## RELAYS (NONWIRE SPRING-TYPE), 197-TYPE SWITCHES, CROSSBAR SWITCHES, AND KS-13835 (AMA) READER REPLACING CONTACTS

1.001 This addendum supplements Section 069-310-802, Issue 7.

1.002 This addendum is issued to revise 4.01 and to add new Fig. 4.1.

Fig. 4.1—Dome-Shaped Contact Mating With a Bar Contact

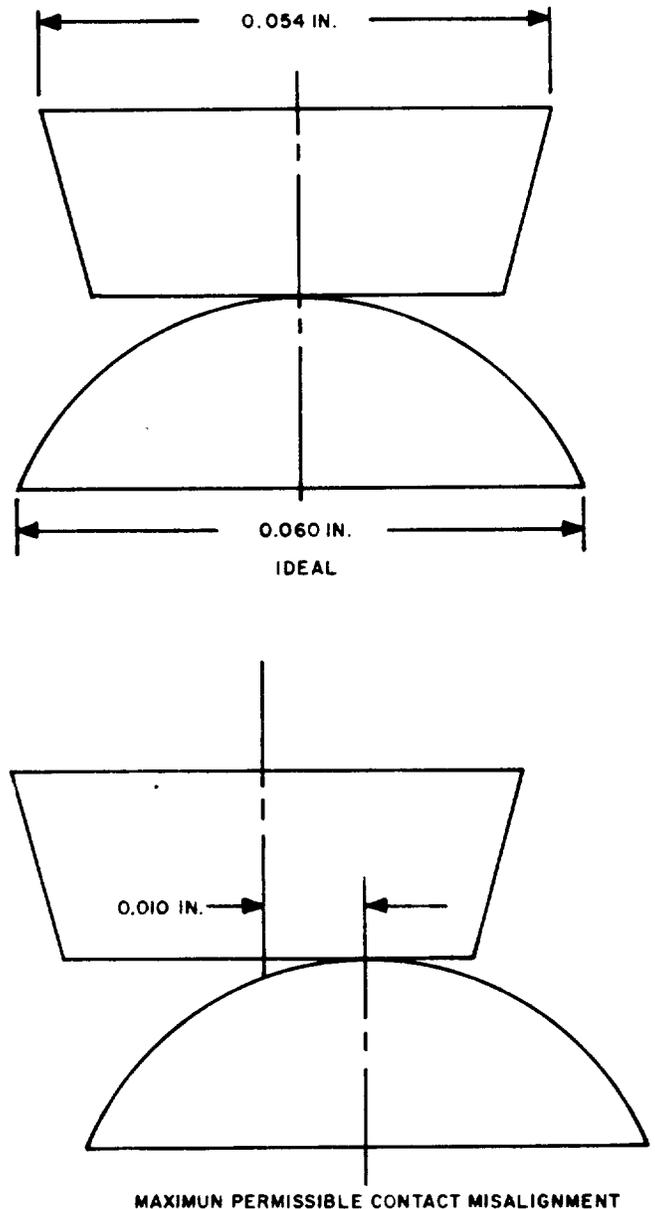
2.002 On Page 8, add Fig. 4.1—Dome-Shaped Contact Mating With a Bar Contact.

4.01 When replacing a point- or disc-type contact, its mating contact must also be replaced. Also, if there is a point-type contact on the opposite side of the spring from the contact to be replaced, the contact on the opposite side and its mate must also be replaced. On step-by-step relays with dome-shaped contacts and on relays equipped with springs having single bar contacts, do not replace the mating contact if it is not necessary. In this case, the dome must lie wholly within the length of the bar and the center line of the dome must be within 0.010 inch of the center line through the width of the bar as gauged by eye. (See Fig. 4.1.)
